Access Compliance Report

Public Rights-of-Way

Intersection ID: 12164	Main Street: SEIGLE_AV	Cross Street: BELMONT_AV	Location: W
ADA ID: 3AB5D29DF1C3	Ramp Type: BlendTrans1	Initial Pass/Fail: Fail	Overall Compliance: No
			Severity Score: 33.75

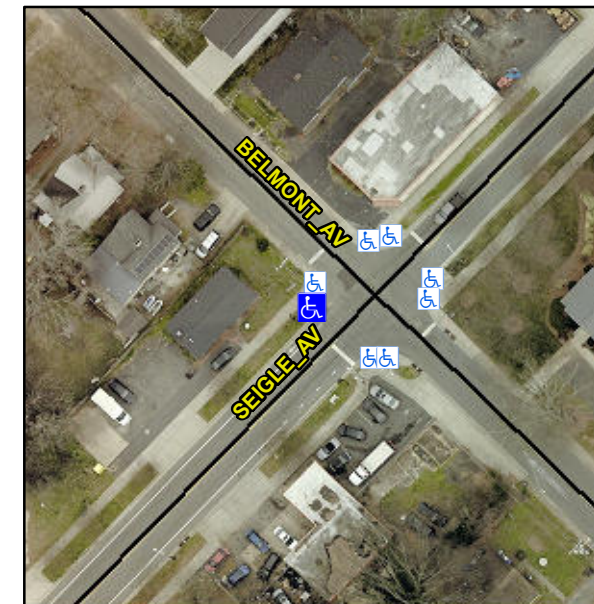
Not Found, R304.5.1, R304.5.3

Compliance	Description	Data	Compliance	Description	Data
N/A	Ramp Length (in)	74.0	Yes	BlendTrans Slope (%)	0.7
No	Ramp Width (in)	47.5	No	BlendTrans XSlope (%)	8.1
N/A	Flare Type LT	N/A	N/A	Flare Type RT	N/A
N/A	Flare Slope LT (%)	N/A	N/A	Flare Slope RT (%)	N/A
N/A	Flare Traversable LT?	N/A	N/A	Flare Traversable RT?	N/A
N/A	Landing Length (in)	N/A	N/A	DWS Provided?	N/A
N/A	Landing Width (in)	N/A	N/A	DWS Contrast?	N/A
N/A	Landing Slope (%)	N/A	N/A	DWS Length (in)	N/A
N/A	Landing X Slope (%)	N/A	N/A	DWS Full Width?	N/A
N/A	Landing Curb? (Y/N)	N/A	N/A	DWS Offset (in)	N/A
N/A	Shared Landing?	N/A			
N/A	Gutter Ponding?	N/A	N/A	Gutter Slope (%)	N/A
N/A	Gutter Lip Ht (in)	N/A	N/A	Gutter X Slope (%)	N/A
N/A	Painted X Walk1?	No	N/A	Painted X Walk2?	N/A
	X Walk 1 Direction	To SE		X Walk 2 Direction	N/A
	X Walk 1 Width (in)	N/A		X Walk 2 Width (in)	N/A
	X Walk 1 Slope (%)	6.2		X Walk 2 Slope (%)	N/A
	X Walk 1 X Slope (%)	2.4		X Walk 2 X Slope (%)	N/A

N/A	Ramp inside XWalk1?	N/A	N/A	Ramp inside XWalk2?	N/A
	Road Slope (%)	2.4		Clear Space?	N/A
	Road X Slope (%)	6.2	N/A	Clear Space to XWalk (in)	N/A
N/A	Any Obstructions?	N/A	N/A	Storm Grate/Utility Hazard?	N/A
	Obstruction Type			Storm Grate/Utility Type	
		N/A			N/A
			Yes	Surface Condition? (G/P)	Good
			No	Curb Slope (%)	16.2

Remove & Replace Curb Ramp With Two New Directional Ramps or Equivalent.
